MCC RFI 0104 Sketch SK1
ref. Sheet M2.1h

BUILDINGS 5 & 6 RENOVATIONS
San Mateo County Community College District

CAÑADA COLLEGE
4200 Farm Hill Boulevard
Redwood City, CA 94061

MECHANICAL
HYDRONIC PLAN
FIRST FLOOR

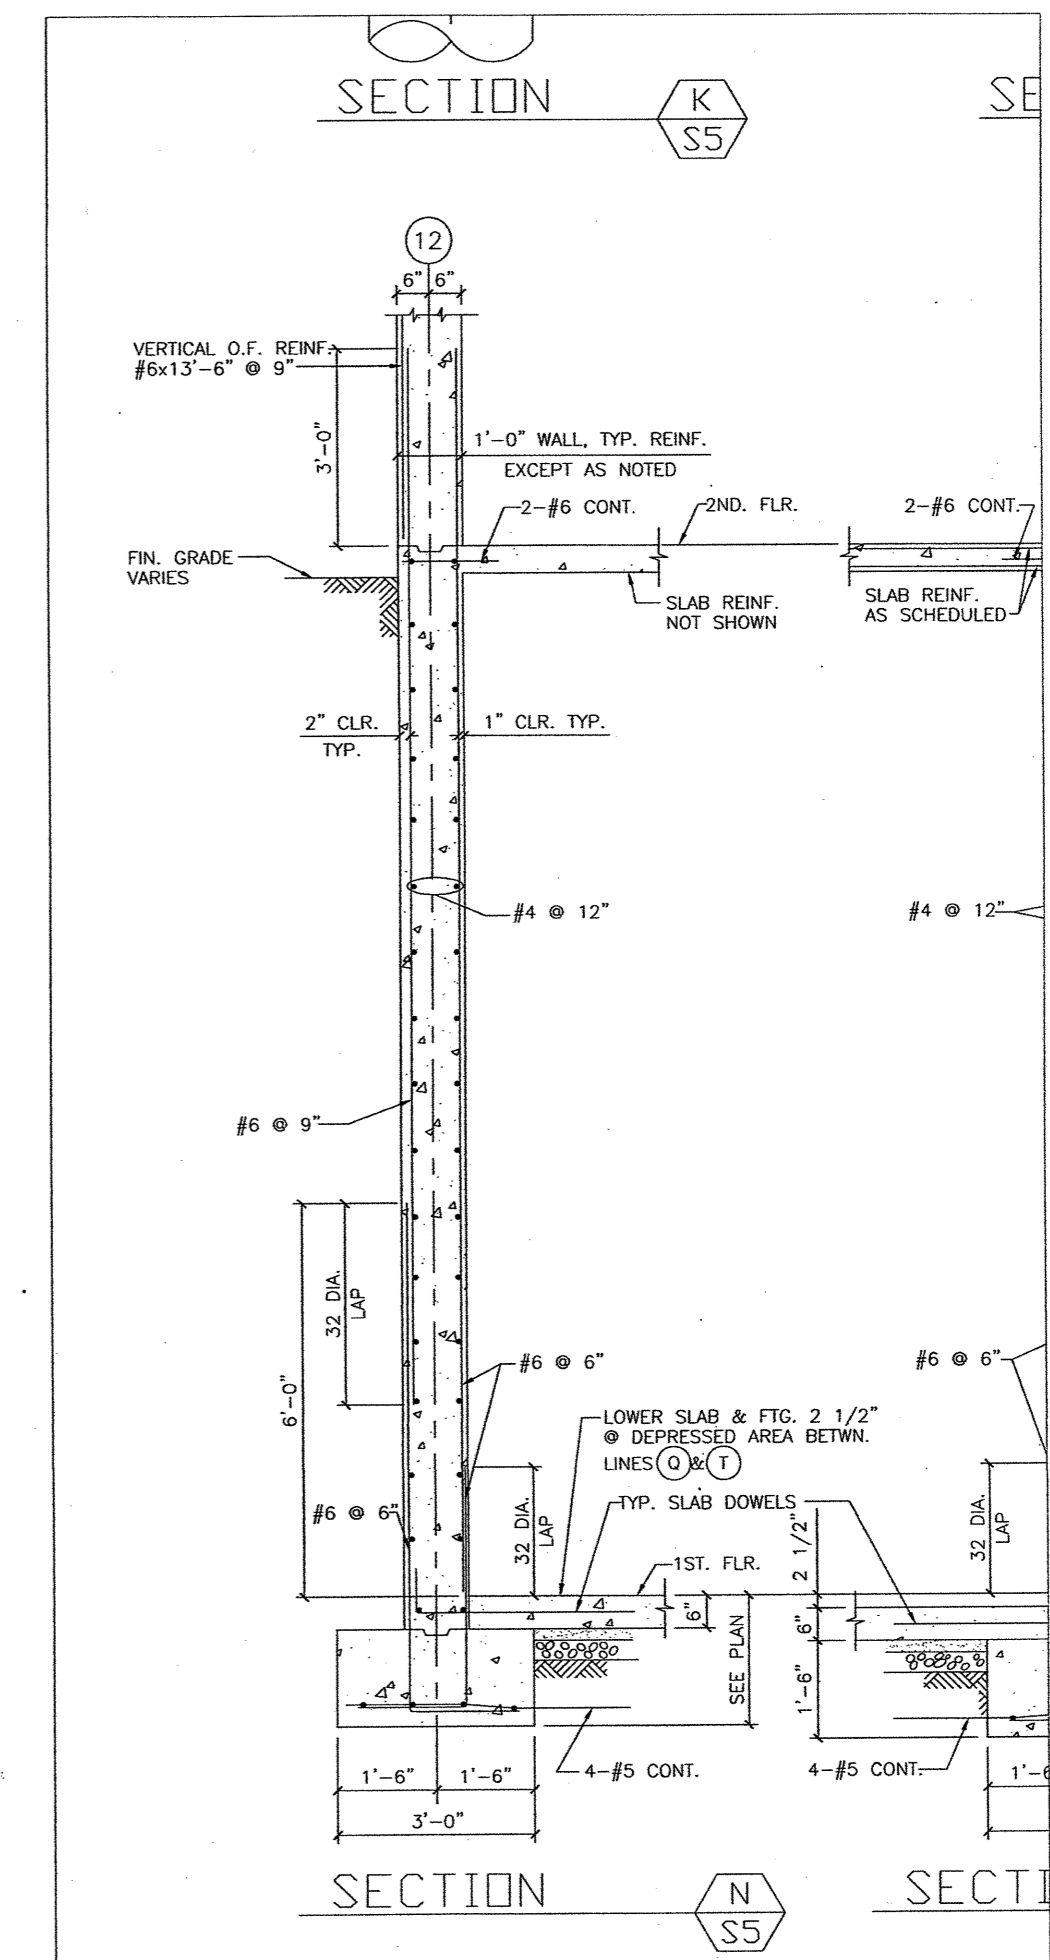
SEE RFI-104
